SUNDRY NOTICES AND REPORTS ON WELLS

8. Well Name and No.
HALLERTAU 5 FEDERAL 11H

Cimarex respectfully request approval to change the drilling plan (casing, cement & mud) for the above referenced well. Please see attached drilling plan. Cimarex also requests approval for a multibowl well head, please see attached diagram and procedure.

PECOS DISTRICT
DRILLING CONDITIONS OF APPROVAL

Cactus Multi-Bowl Wellhead Steps:

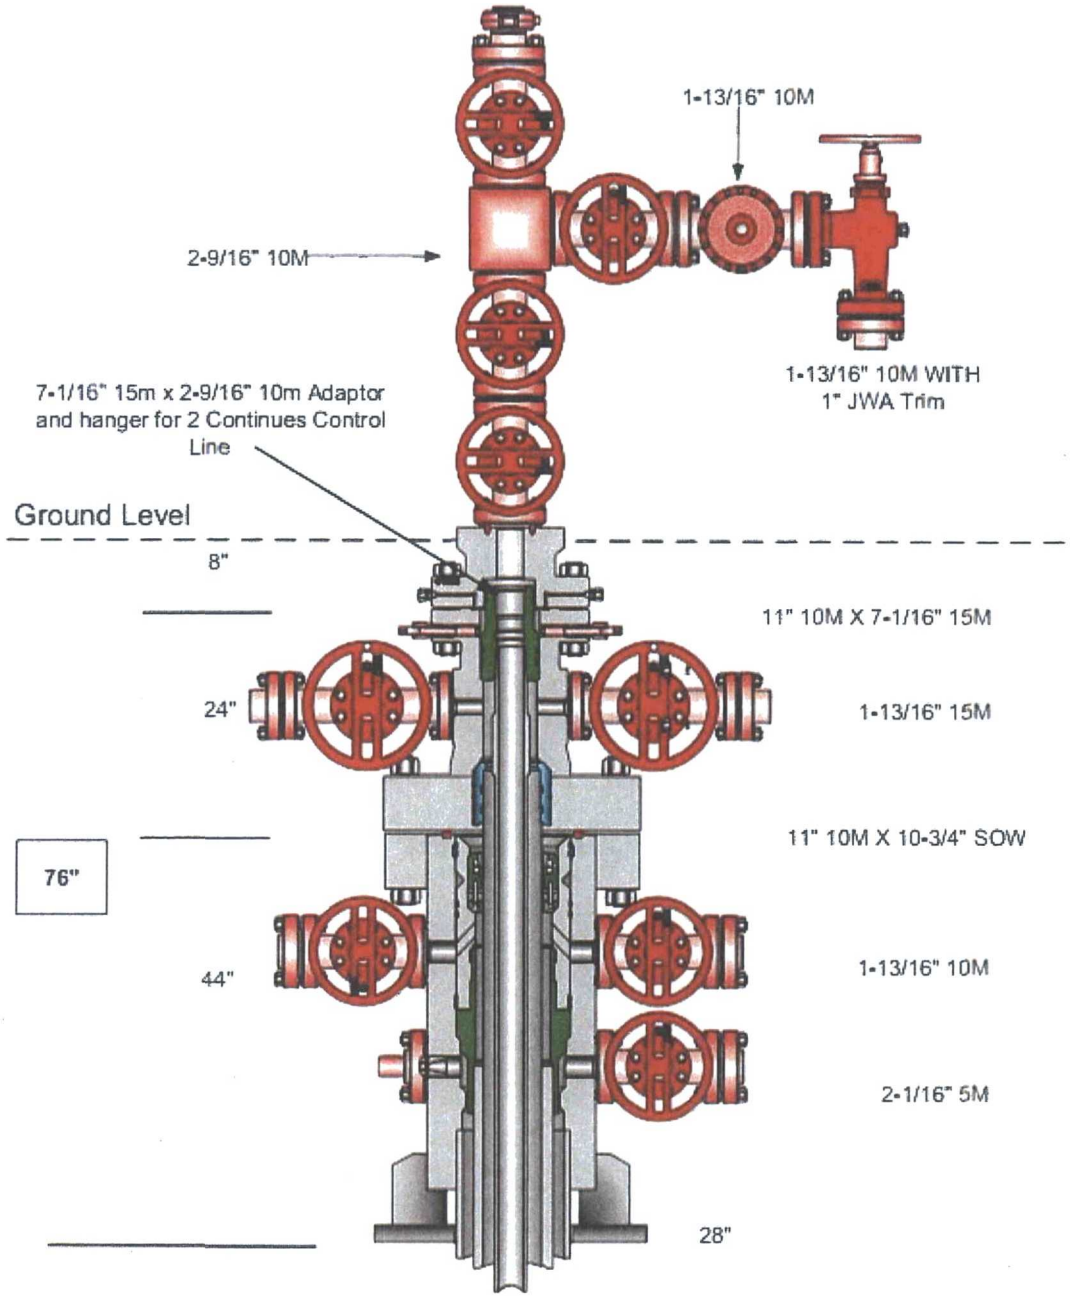
Operator has proposed a multi-bowl wellhead assembly. This assembly will only be tested when installed on the surface casing. Minimum working pressure of the blowout preventer (BOP) and related equipment (BOPE) required for drilling below the surface casing shoe shall be 10,000 (10M) psi.

a. Wellhead shall be installed by manufacturer's representatives, submit documentation with subsequent sundry.
b. If the welding is performed by a third party, the manufacturer's representative shall monitor the temperature to verify that it does not exceed the maximum temperature of the seal.
c. Manufacturer representative shall install the test plug for the initial BOP test.
d. If the cement does not circulate and one inch operations would have been possible with a standard wellhead, the well head shall be cut off, cementing operations performed and another wellhead installed.
